INLAND FISHERIES AND WILDLIFE NATURE PARK - ADDENDUM #1

date: May 13, 2024
project: Inland Fisheries and Wildlife Store and Admin Office Project # 3096
prepared by: Ryan Kanteres Simons Architects
Adam Wiles-Rosell Simons Architects
Mikayla Molta Simons Architects

Subject: **Addendum #1** to Bid Documents of April 23, 2024

A140

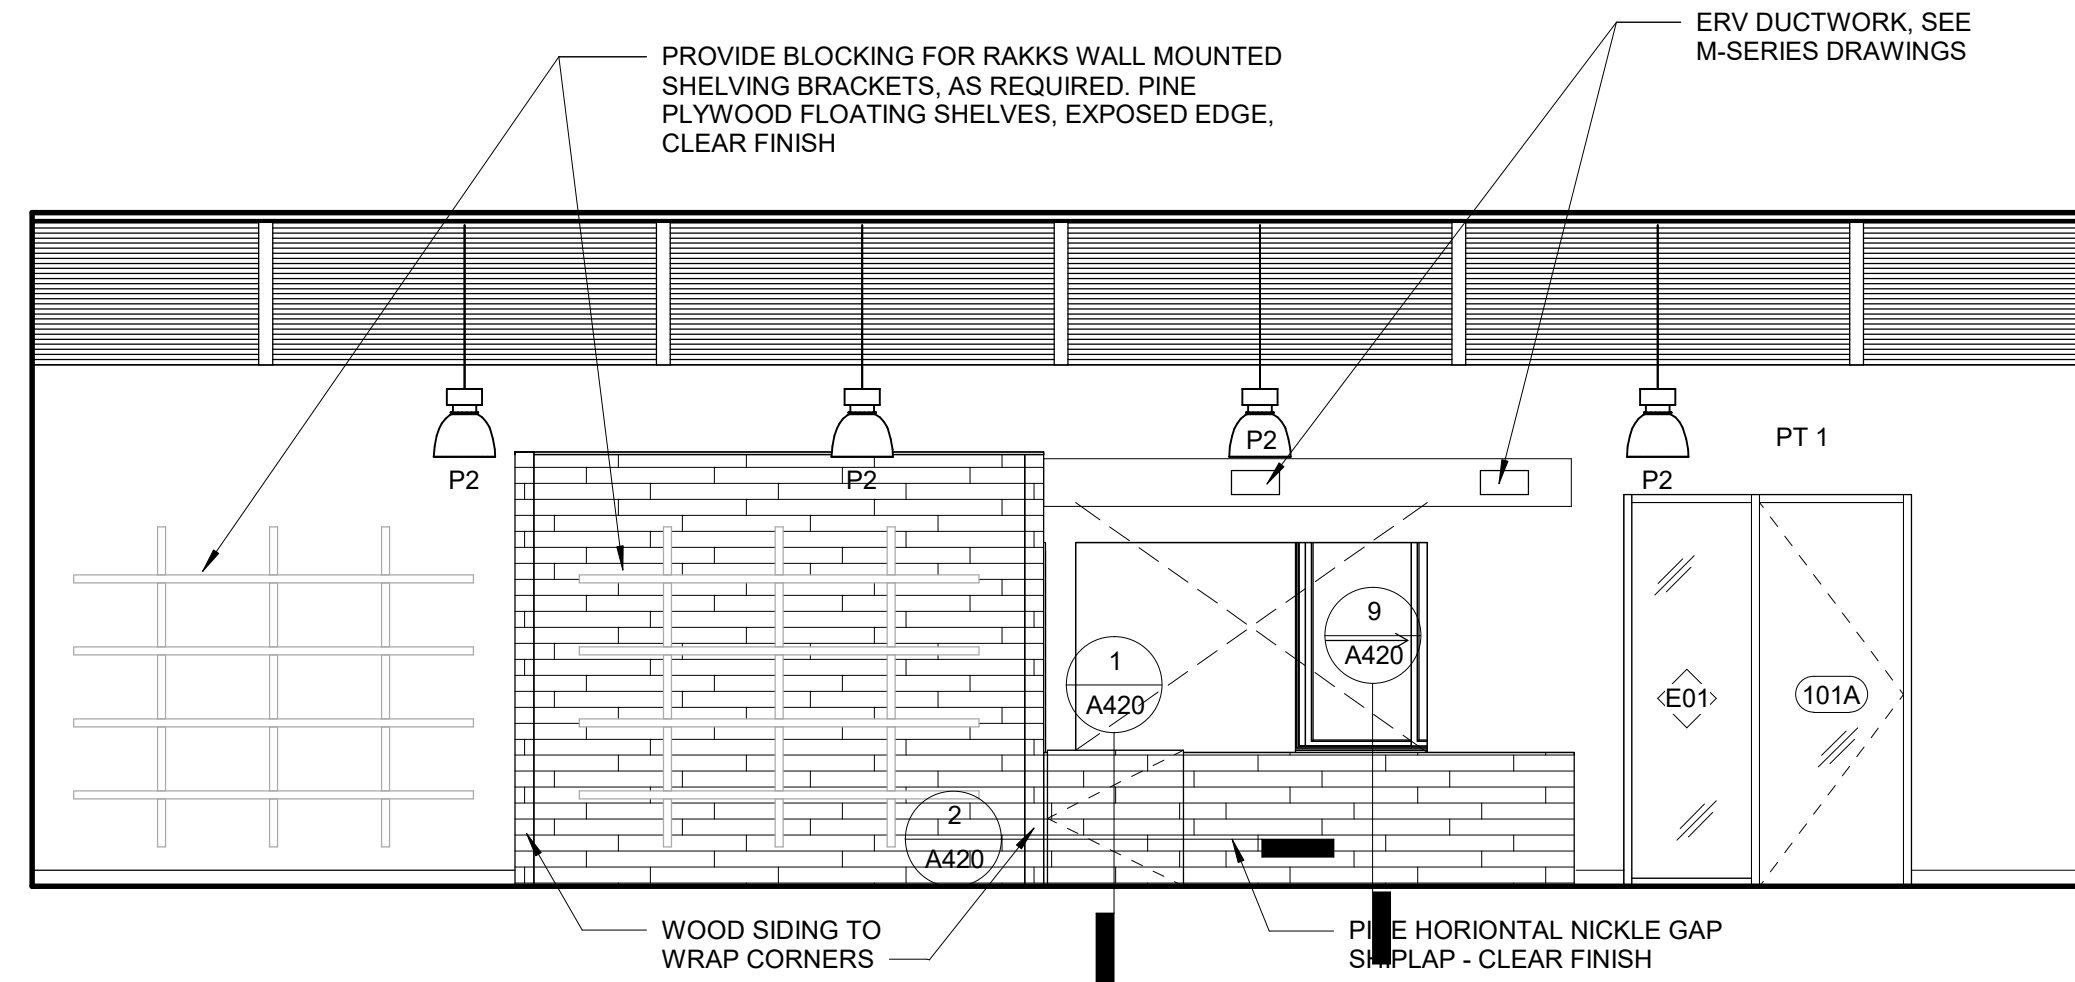
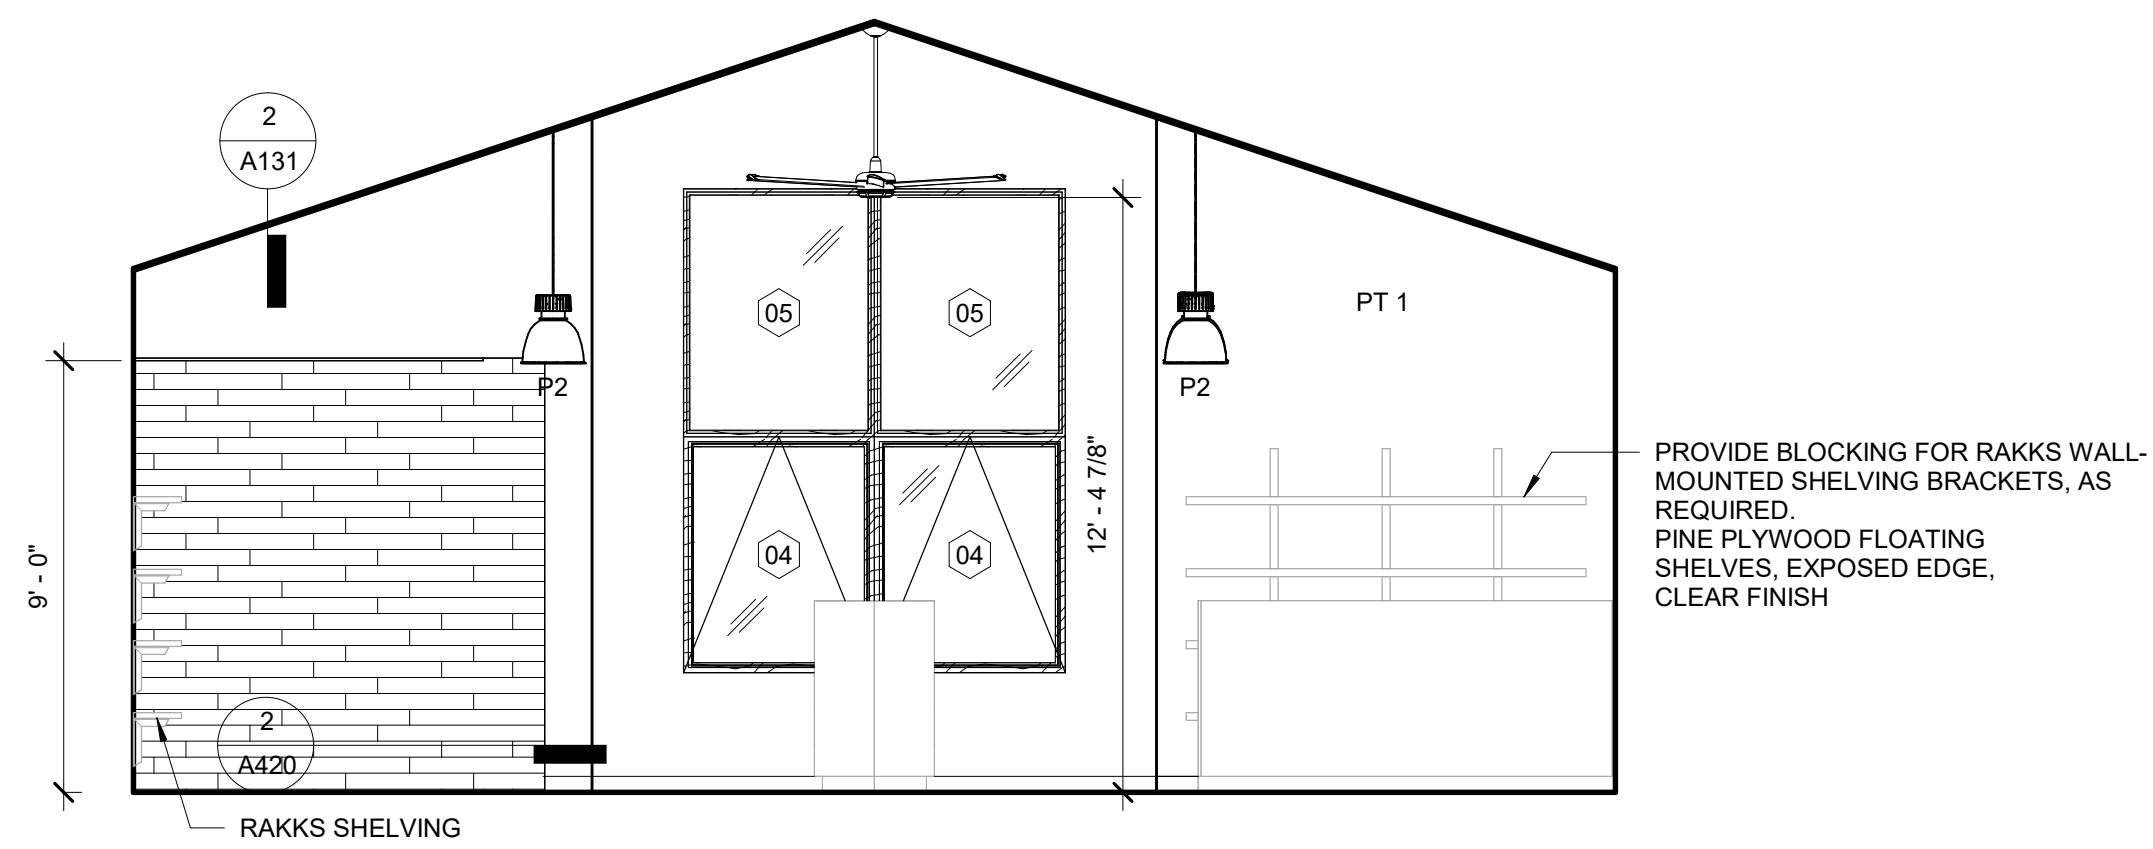
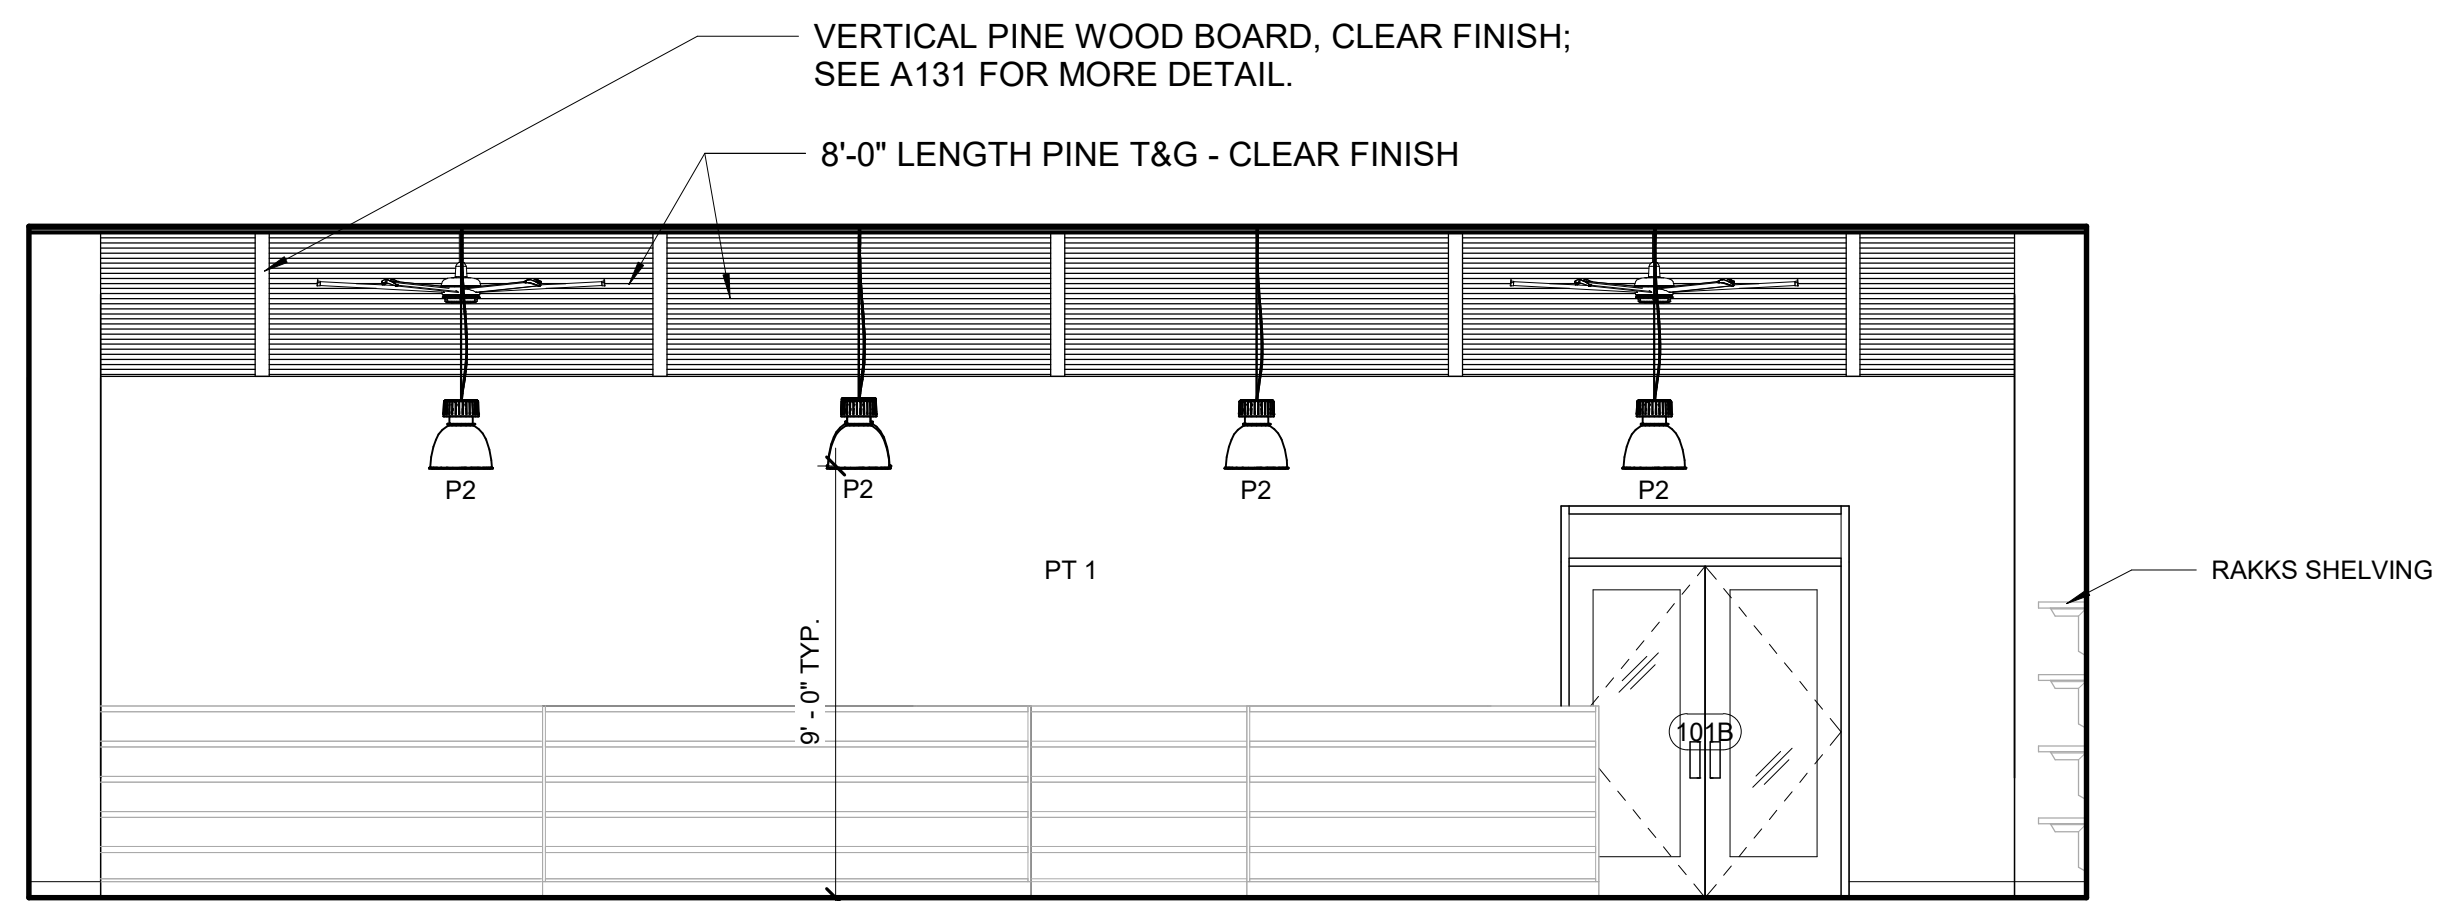
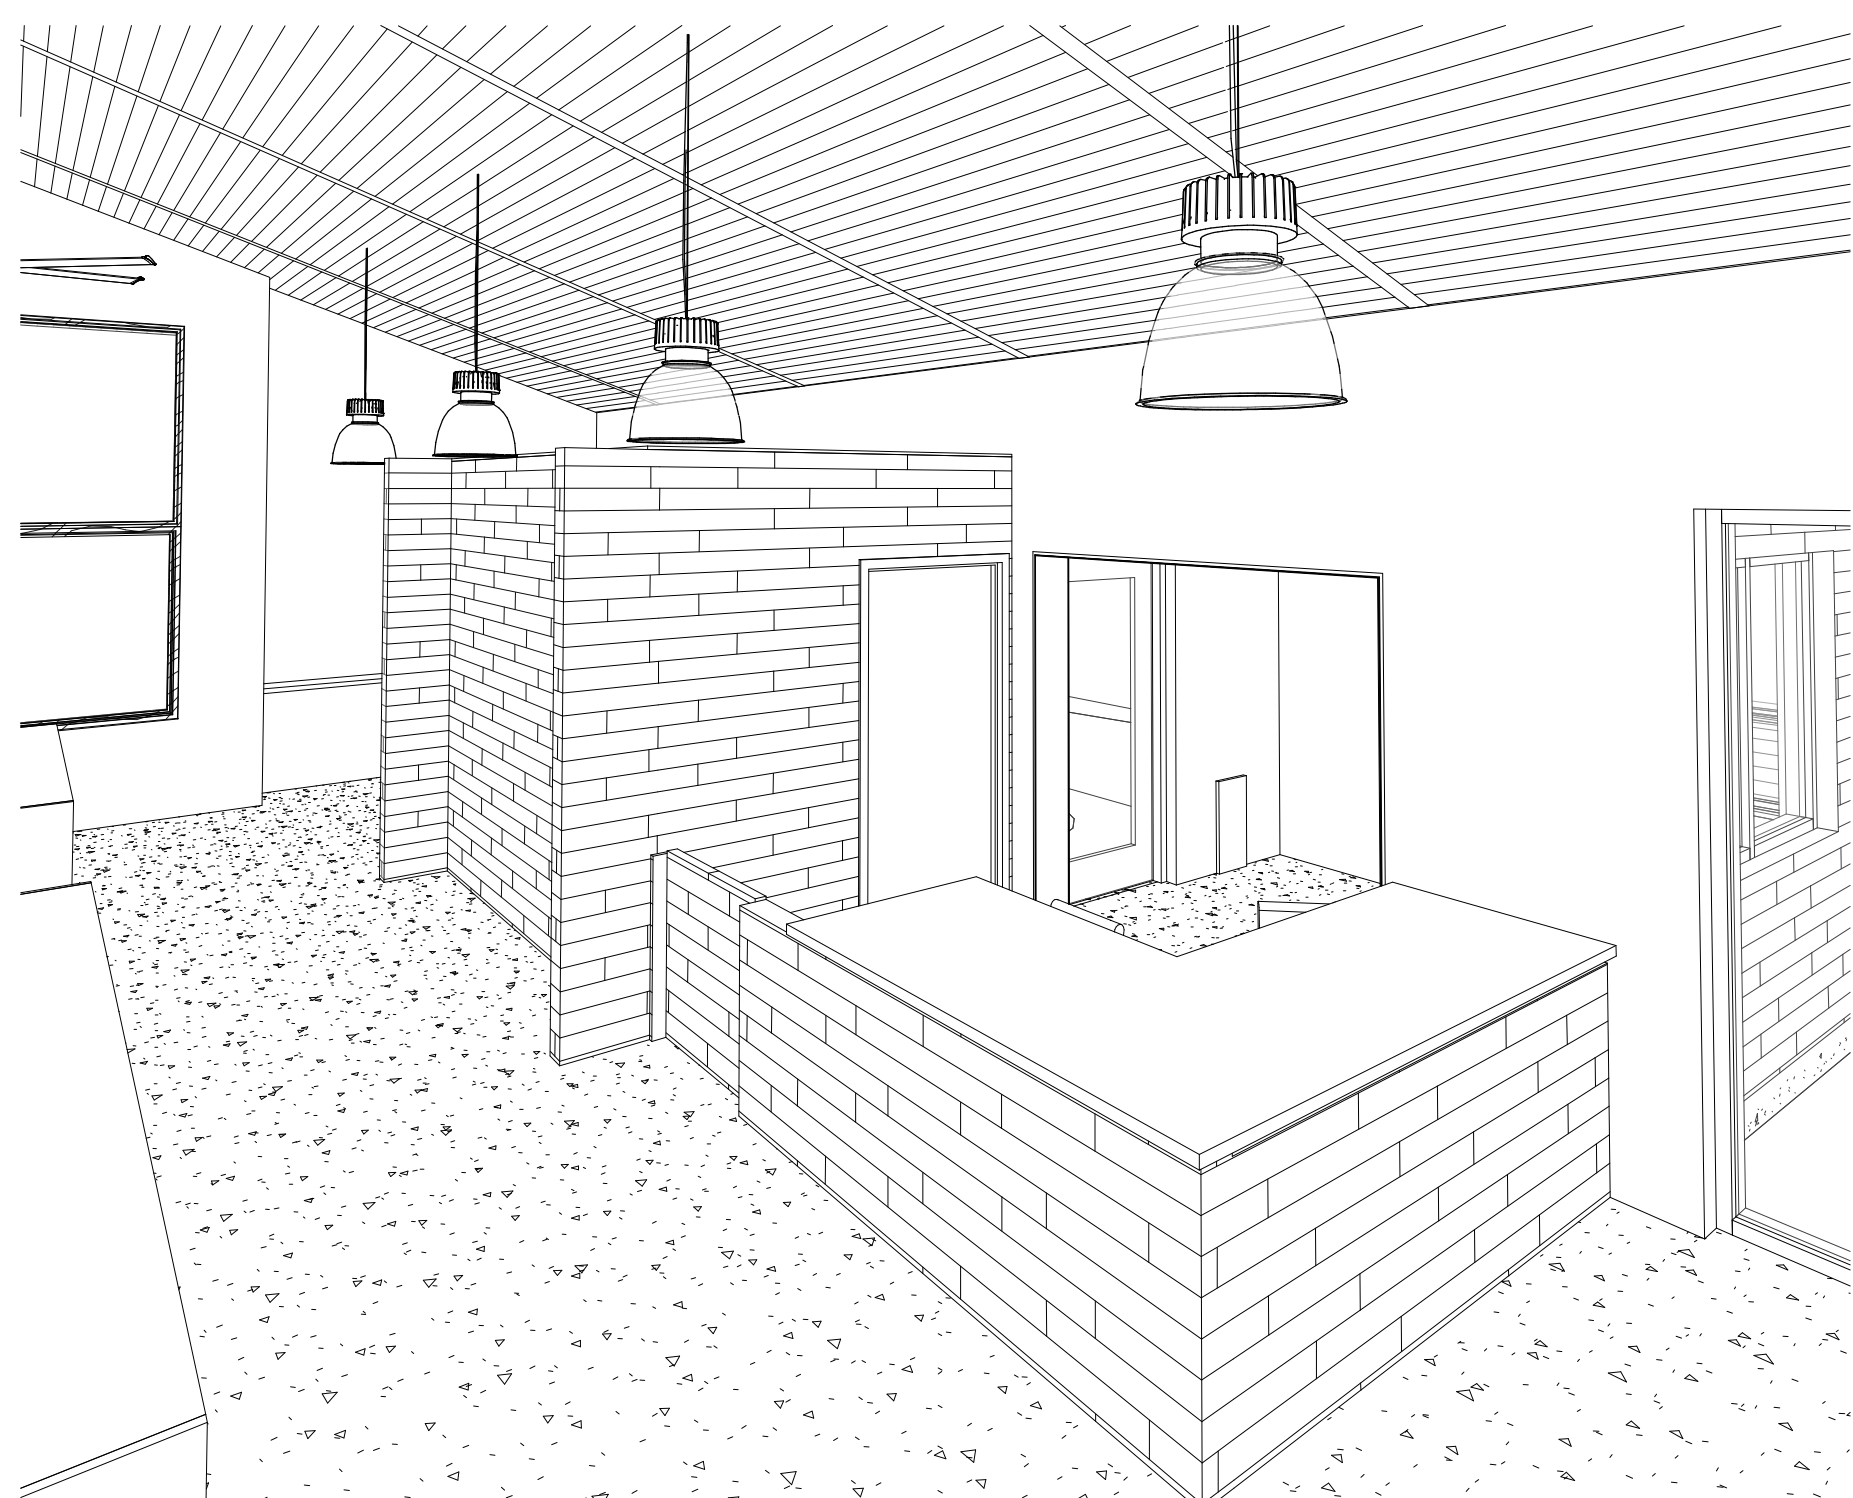
- 1-D10 Sheet A140 Located recessed fire extinguisher cabinet.
- 1-D11 Sheet A142 Coordinated interior elevations with plumbing schedule to show floor-mounted water closet fixture. Elevation 15 + 16 updated to capture Data Closet venting needs. Millwork elevation updated, see millwork details.
